GROWTH MANAGEMENT DEPARTMENT STAFF REPORT
VILANO BEACH TOWN CENTER OVERLAY DISTRICT

April 12, 2023 Public Meeting

VBTCDR 2023-01 Vilano Beach Townhomes (aka Breakwater Villas)

To: North Coastal Design Review Board
Staff: Sloane Stephens, Planner
Date: April 5, 2023

Conceptual Site Lighting Plan

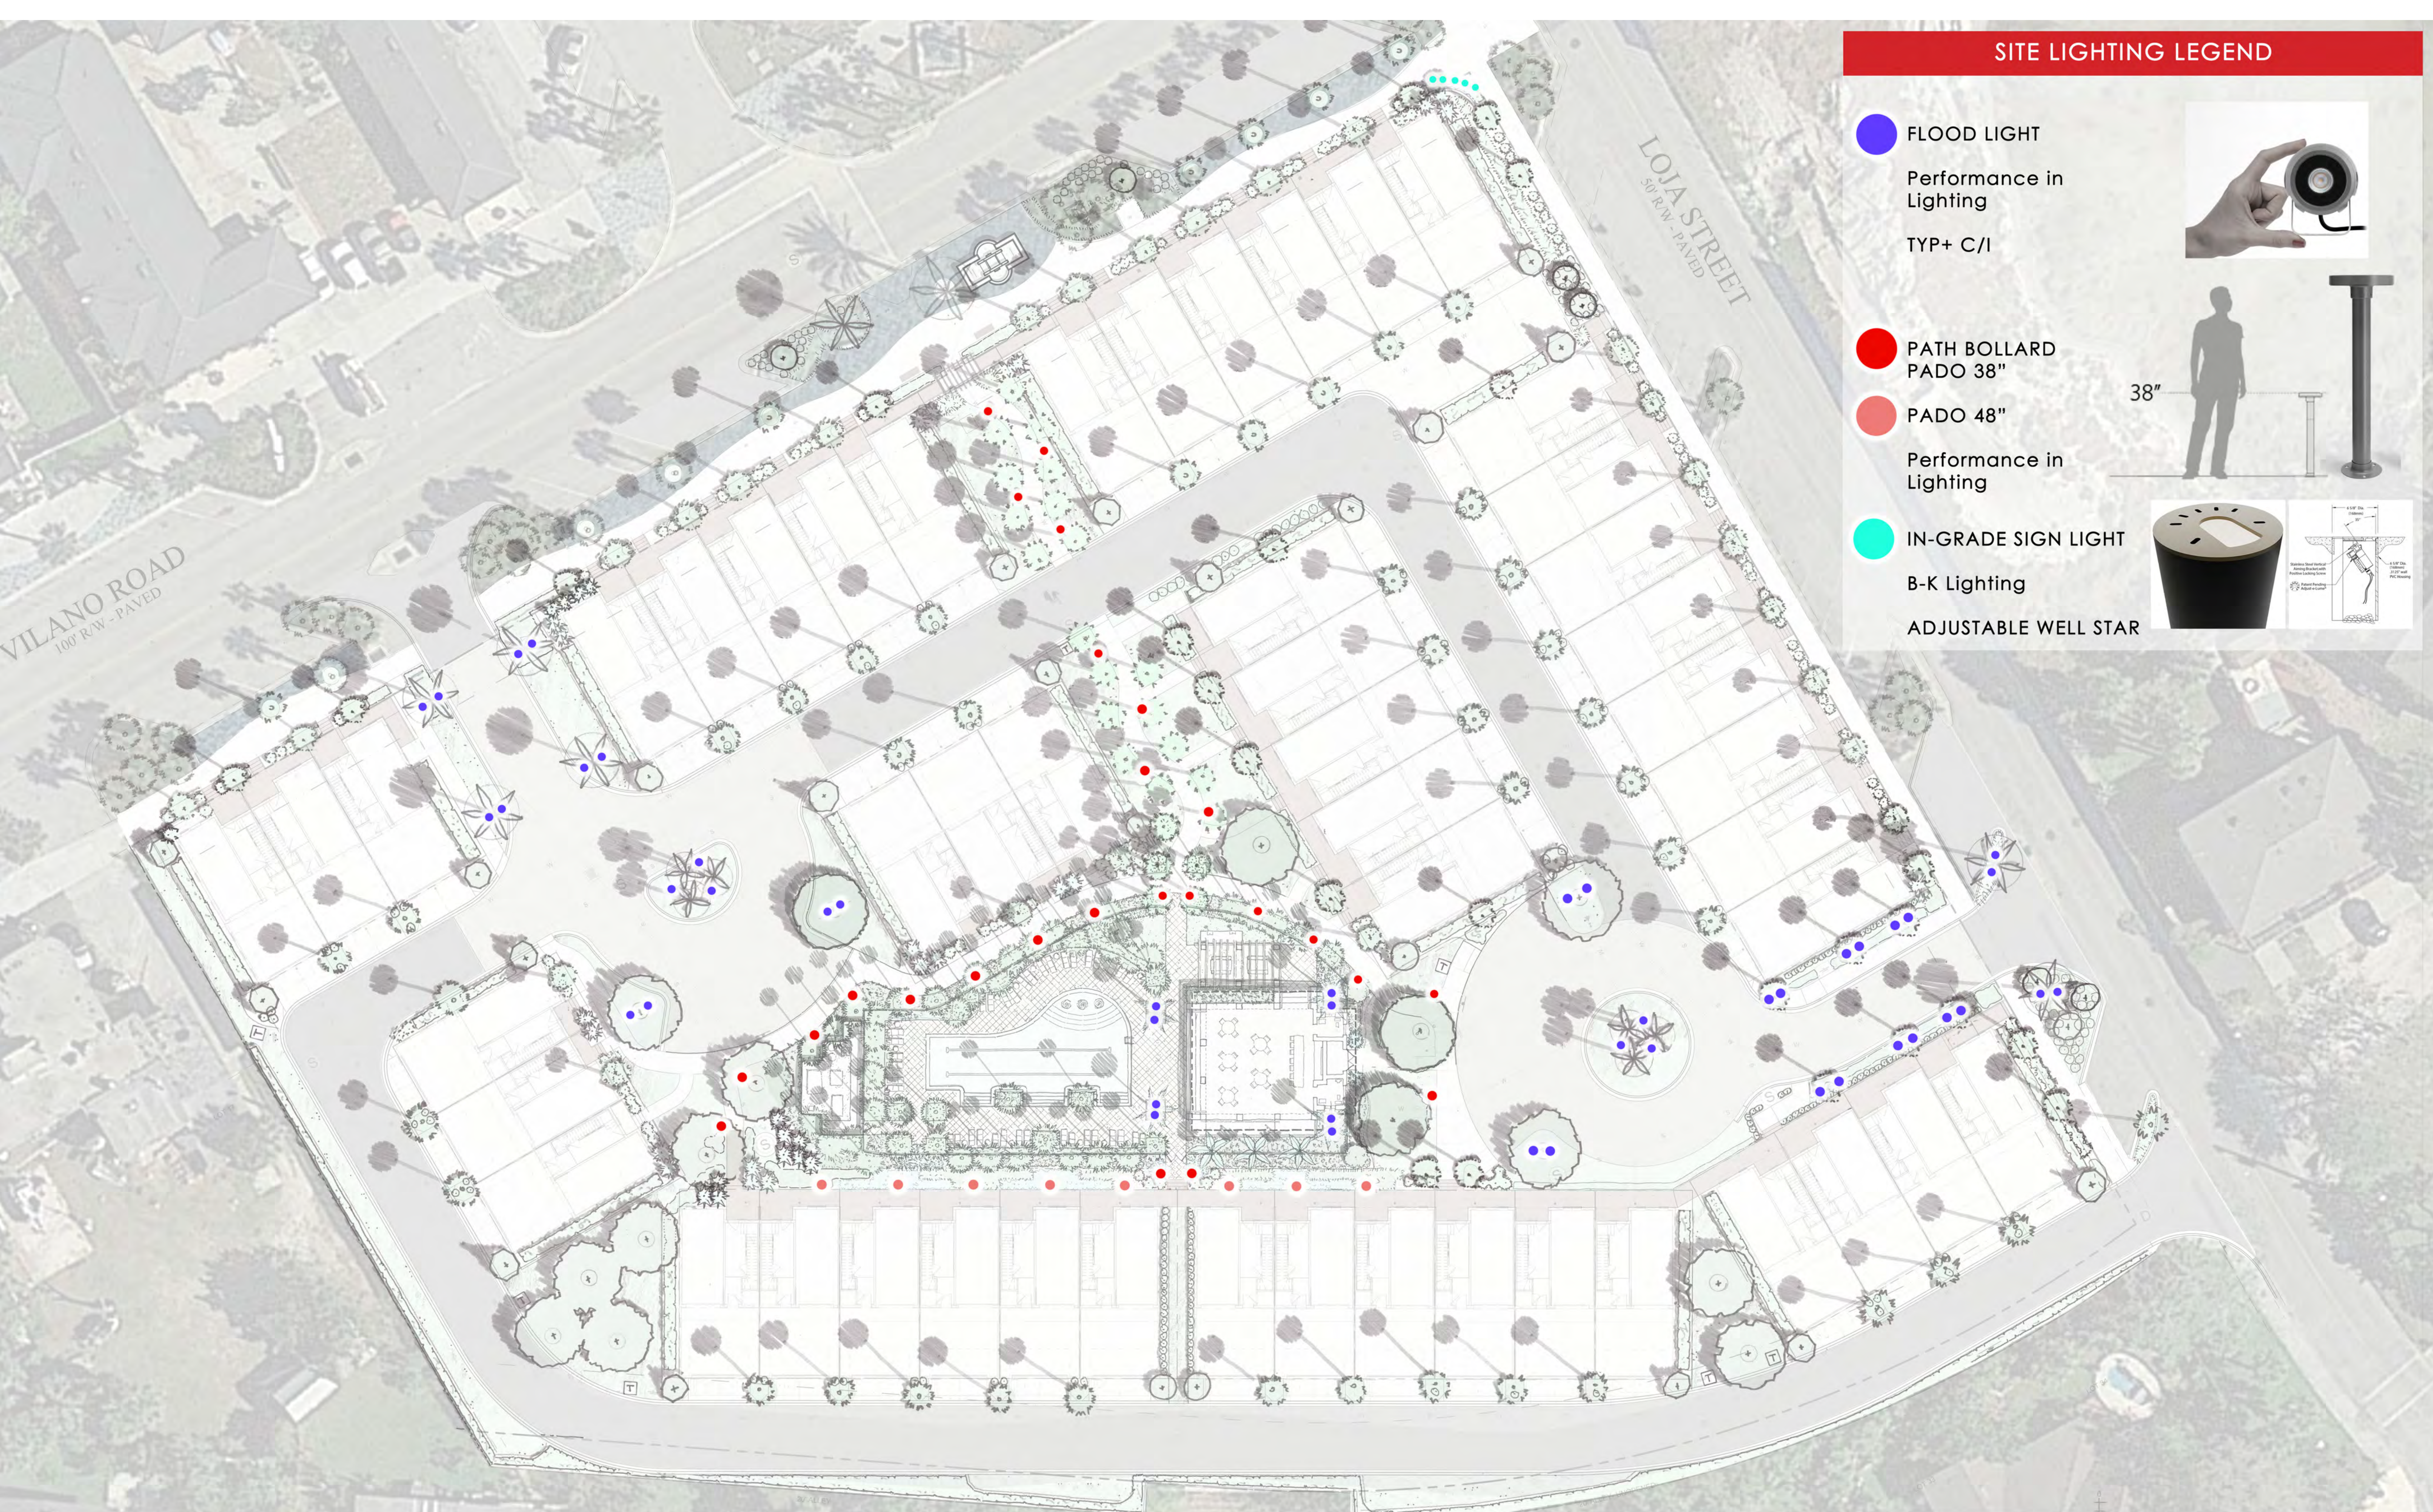
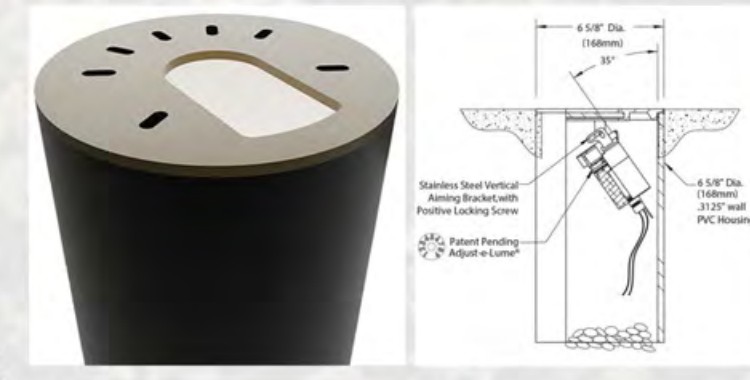
Proposed site lighting includes flood lights, path bollard lighting, and in-grade sign lights. Such lighting shall be downward facing and not be directly seen at ground level more than 100 yards from the light location. All lighting appears to meet the criteria set forth in LDC Section 3.10.04.A.11.

Vilano Road/Loja Street Sign
ELEVATION
1/2" = 1'-0"

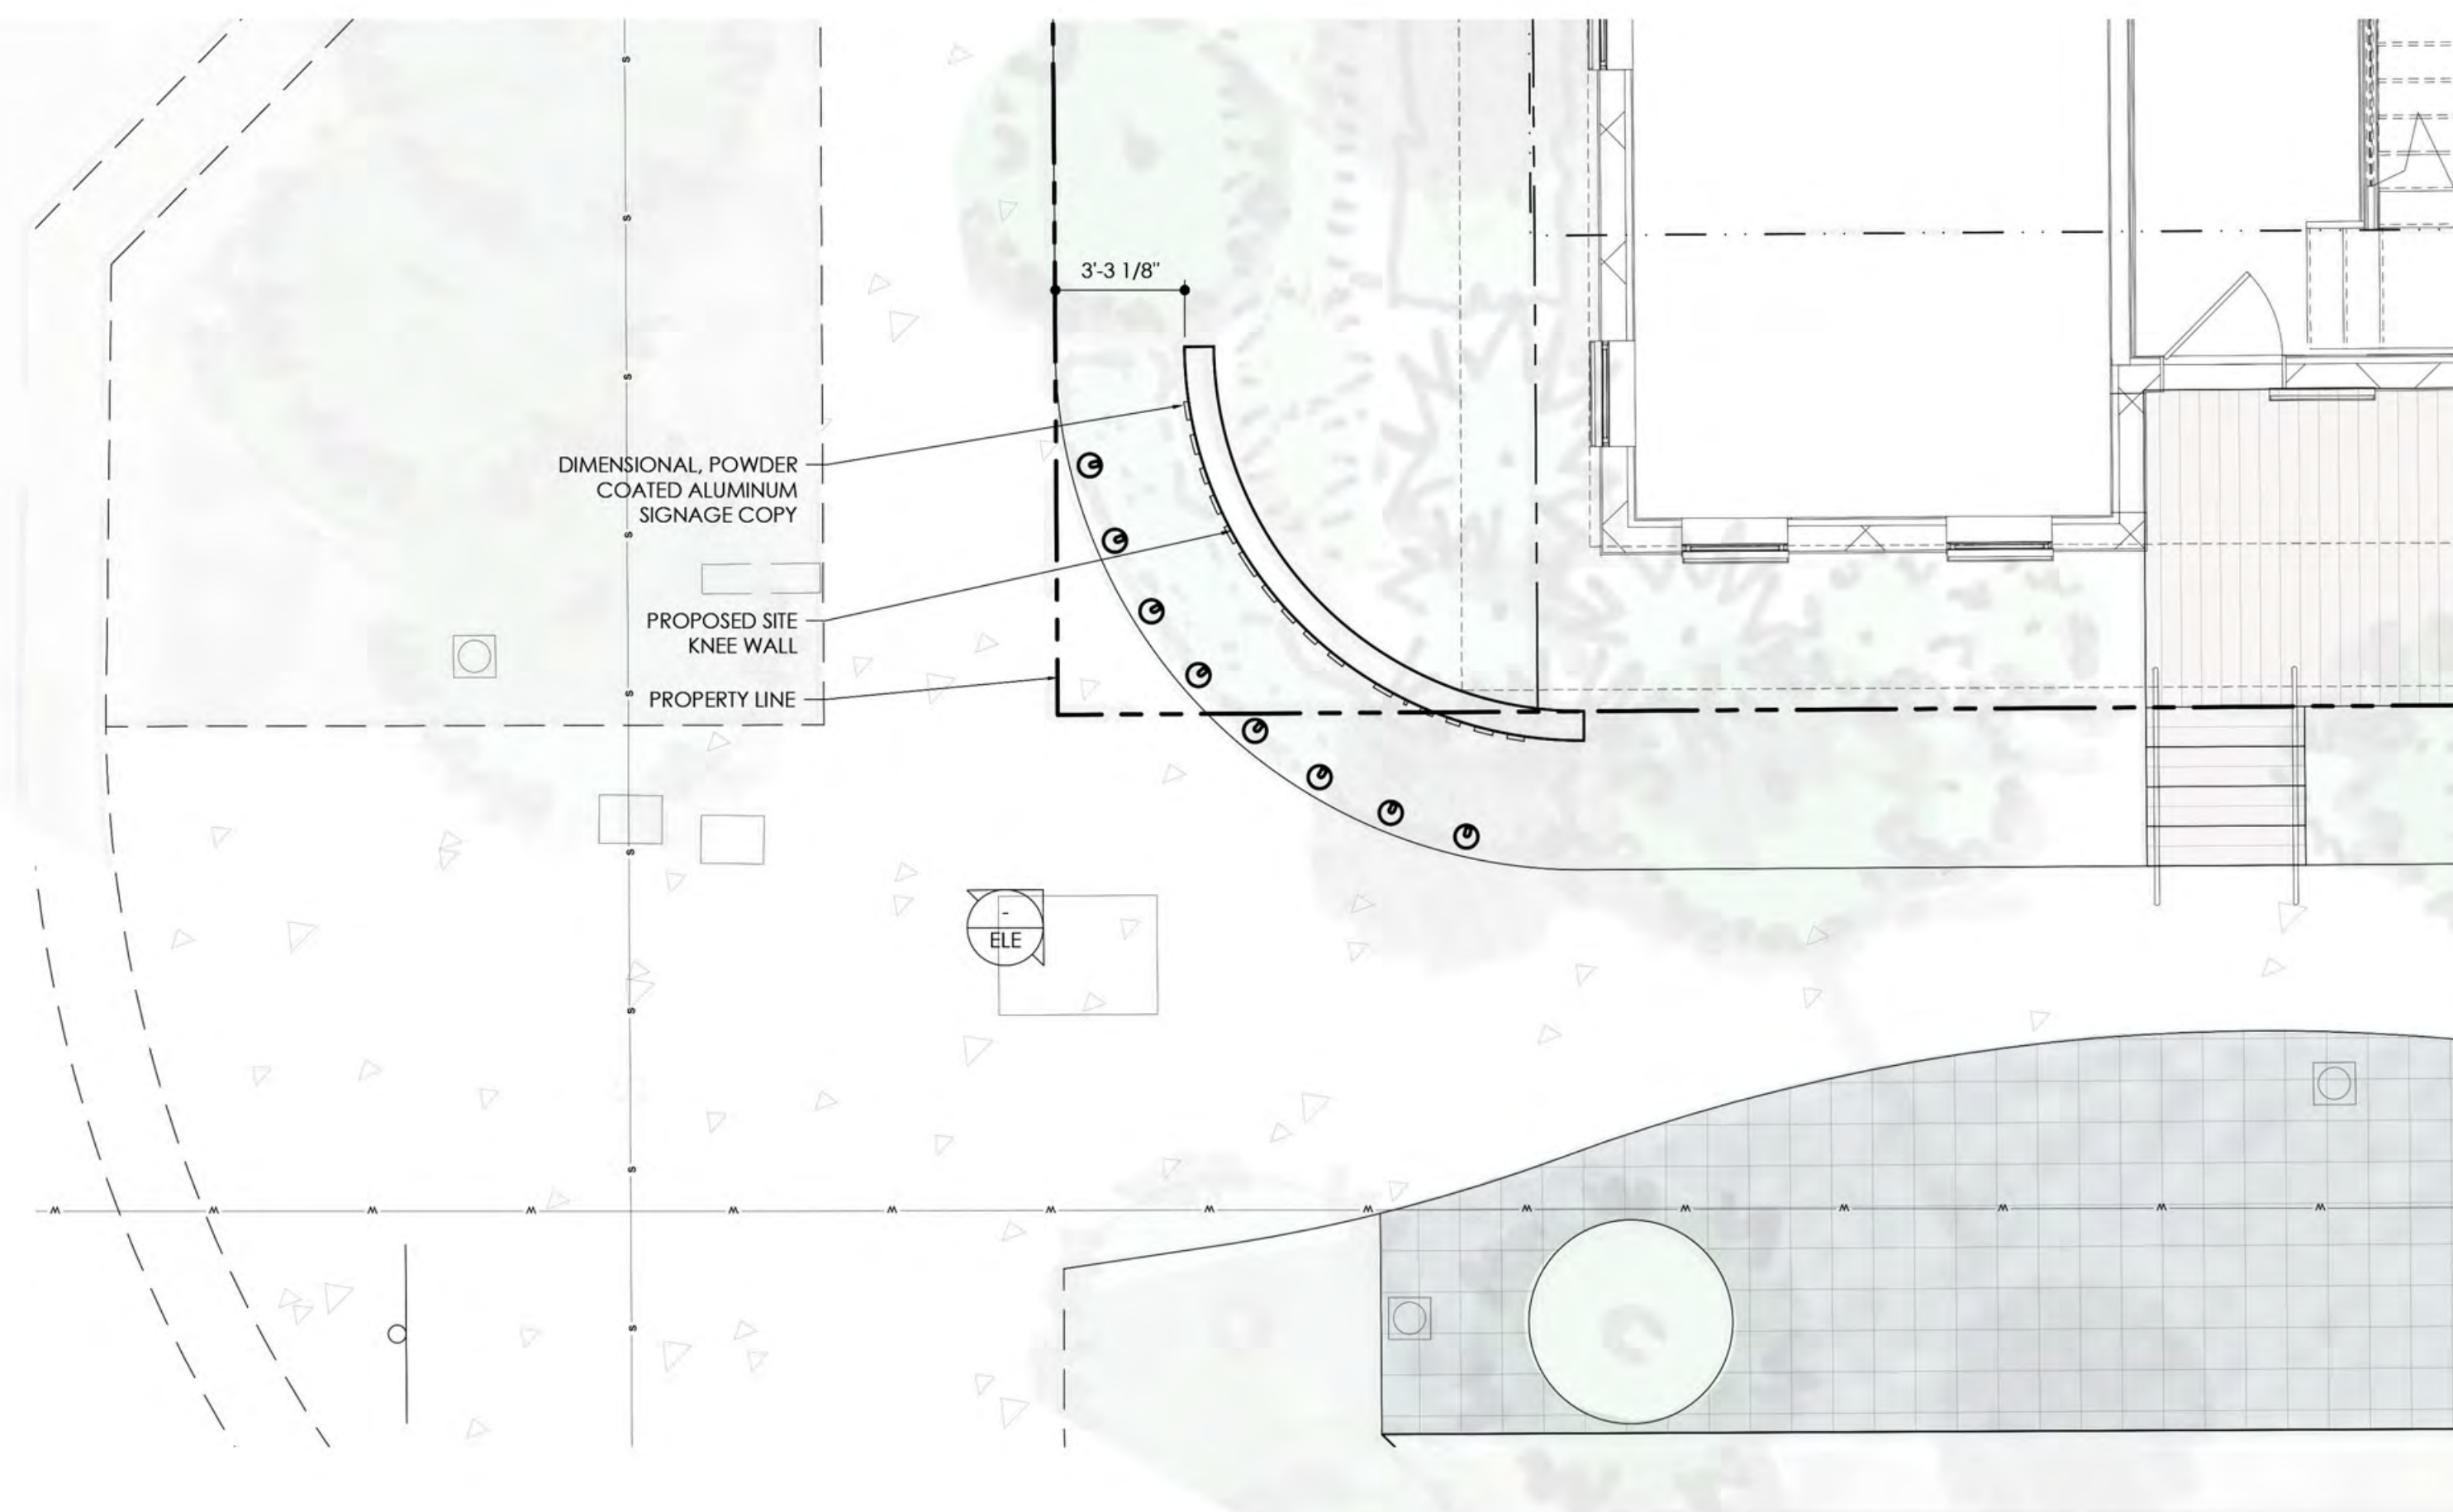
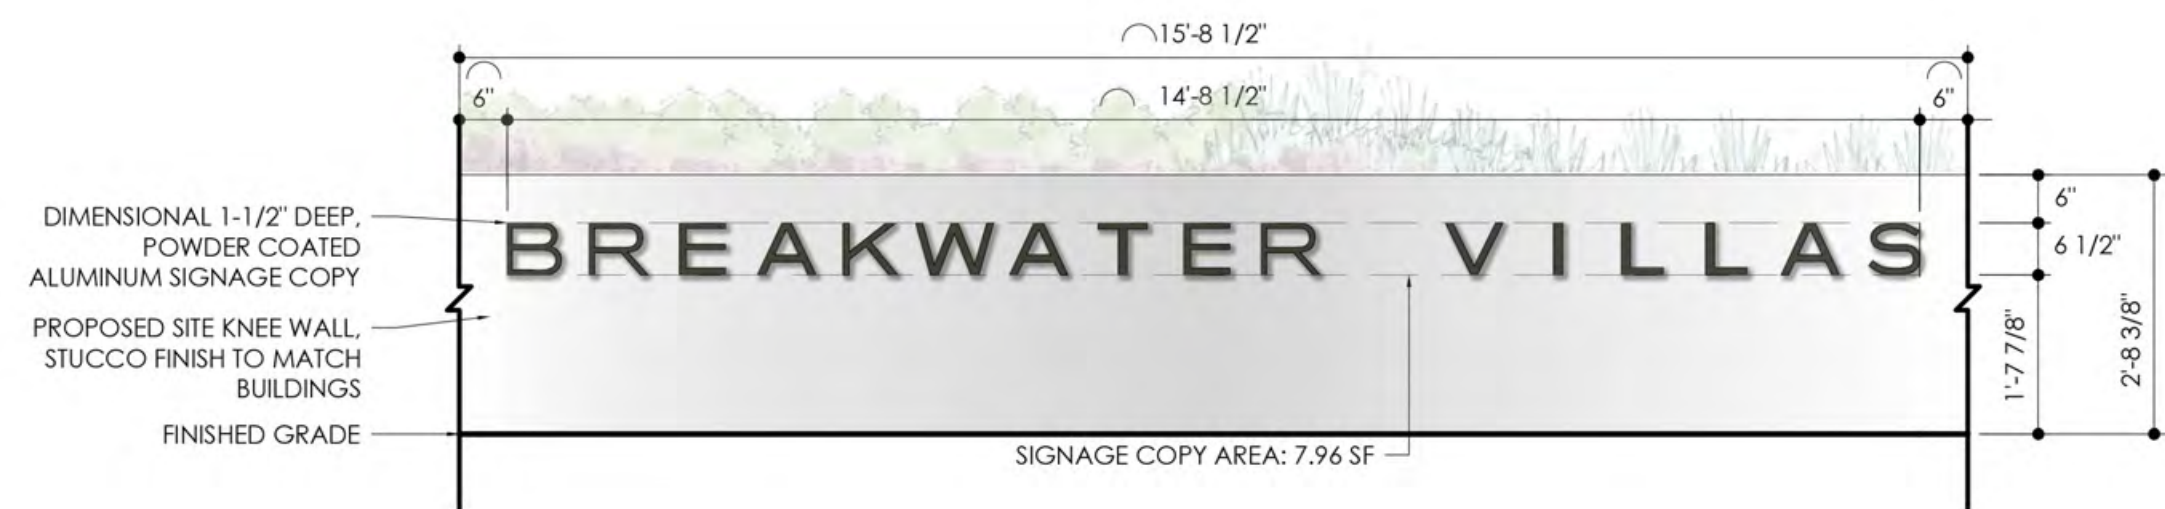
It appears the proposed signage is not a typical sign for the Vilano Beach Town Center Overlay. However, per LDC Section 3.10.05.I.3.e, signage in addition to the items that are specifically allowed for Building Type II shall require approval of the DRB. The proposed sign is ground-monument style, 2'8.375" in height, 15'8.5" in width, in stucco finish to match the townhome buildings. Letters to display "BREAKWATER VILLAS" in powder-coated aluminum. Signage copy area is 6.5" tall by 14'8.5" wide = 7.96 sf total. The sign follows the curve of the sidewalk on the corner of Vilano and Loja Street. It is proposed to be externally illuminated. Please see attached plans for signage elevation and rendering. Per Comprehensive Plan Policy A.3.1.25, pedestrian-friendly signage on sidewalks will be encouraged. Signage shall comply with land development regulations and permitting requirements. Monument signage is prohibited unless designed of a size and scale suited for a pedestrian walkable place. The applicant should further discuss the proposed signage and its consistency with the Vilano Town Center.

Staff notes that the proposed sign plan has a portion of the monument sign encroaching into the right-of-way. The Applicant will need to seek a right-of-way permit for the allowance of signage in the right-of-way, or revise their signage to be within the property boundaries.
